Technical Note TN-NSC100 T2020/40 Control Head LED Backlight Modification

15th August 2005

Resistor Changes

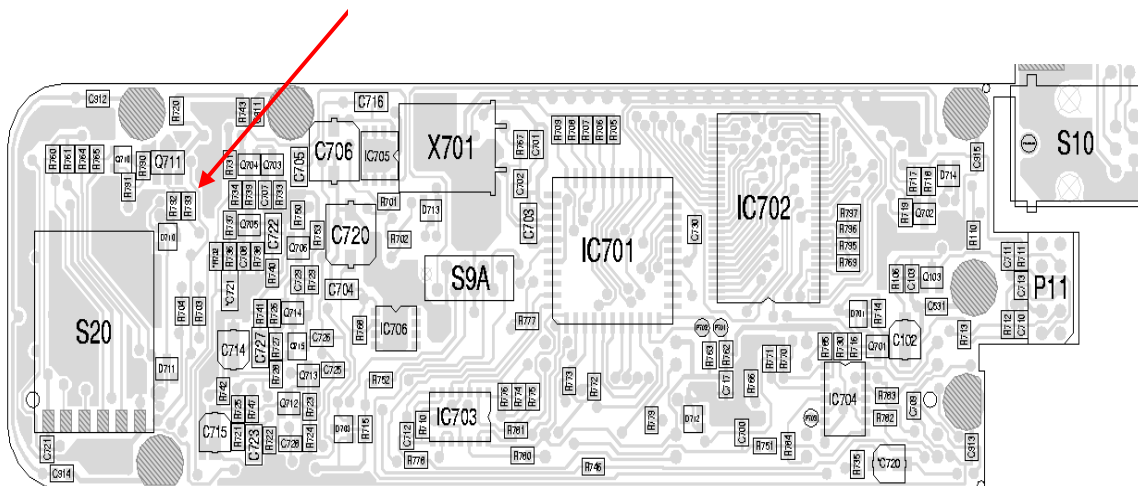
1. The values of resistors R792 & R793 need to be changed. Replace R792 & R793 with a 1k2 & 1k ohm resistors respectively, as per below diagram.

R792 to 1K2 (IPN =036-14120-10)

R793 to 1K (IPN =036-14100-10)

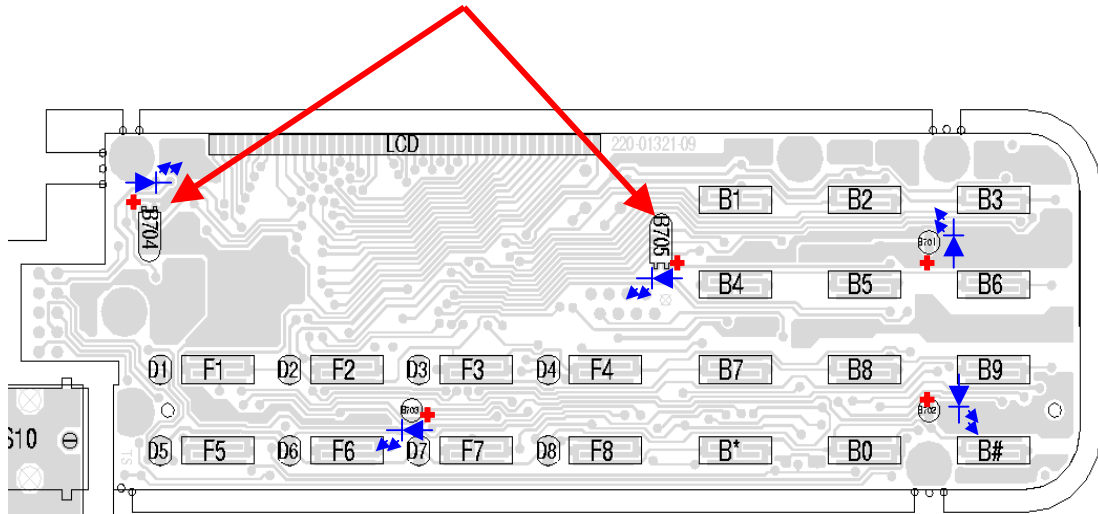
2. Remove the lamps B704 and B705 and fit the two LED's, as per the drawing below.
3. LED's B704 & B705 will need to be folded flat against the board to fit into the cavities of the Lighter Diffuser. The red positive symbol on the diagram indicates the polarity.

B704 and B705 LED IPN = 008-00014-87
